## CITY OF PARRAMATTA COUNCIL

### Traffic Engineering Advisory Group Agenda Item

**ITEM NO:** 2303 B1  
**SUBJECT:** Hill Road, Wentworth Point – Update on the proposed improvements on Hill Road  
**APPLICANT:** City of Parramatta Council  
**REPORT OF:** Traffic and Transport Investigations Engineer  
**WARD:** Rosehill  
**SED:** Auburn

City of Parramatta Council has received an updated detail design of the proposed roundabout with pedestrian crossing facilities at the intersection of Hill Road and Burroway Road, Wentworth Point. This report is to advise Council of the changes to the design from what was previously endorsed by the Parramatta Traffic Committee and Council.

**Figure 2: Updated proposed layout of the proposed roundabout at the intersection of Hill Road, Burroway Road and Lapwing Street, Wentworth Point**

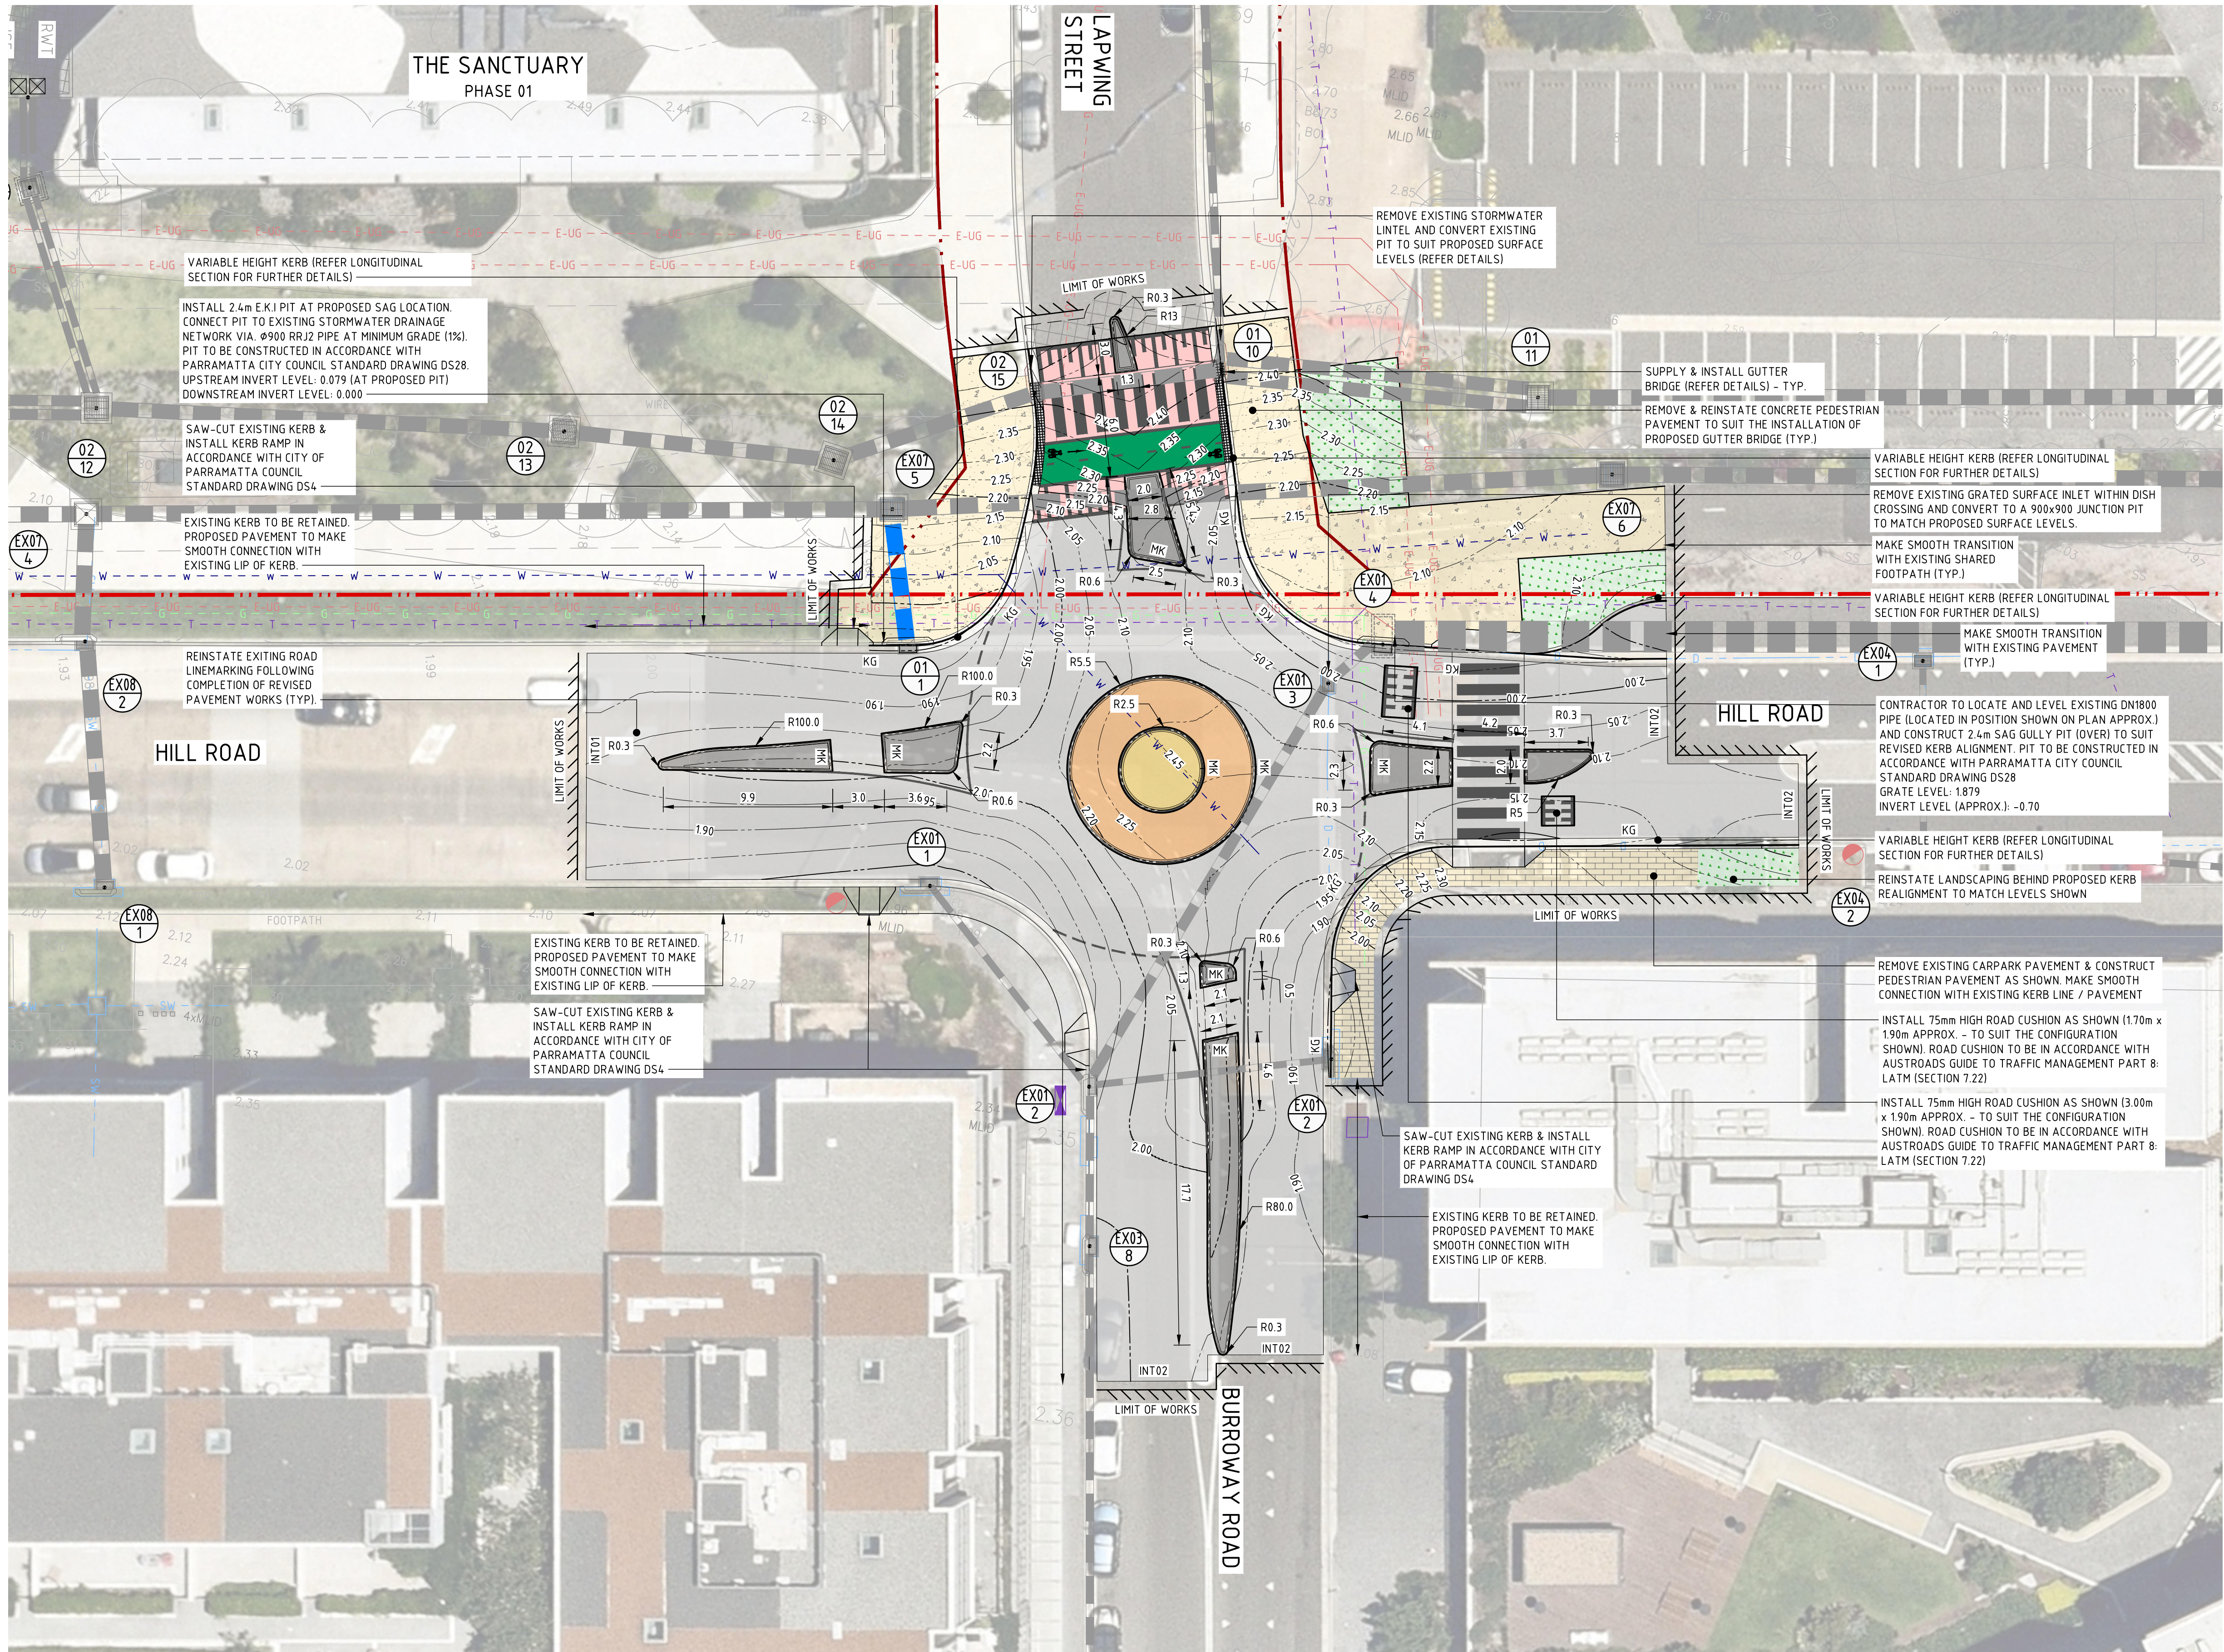
During the detail design stage for the approved roundabout, Council officers and the developer, Sekisui House held further discussions regarding the scope of works. It was agreed that Council will no longer require the construction of a raised pedestrian crossing in the northern leg of Hill Road (also known as Ferry Wharf Circuit) as per resolution 4 above to limit the impact on stormwater drainage. Instead, the scope could be revised to have an at-grade pedestrian crossing with a speed cushion on both approaches. Accordingly, the developer has revised their plans and have submitted them to Council.
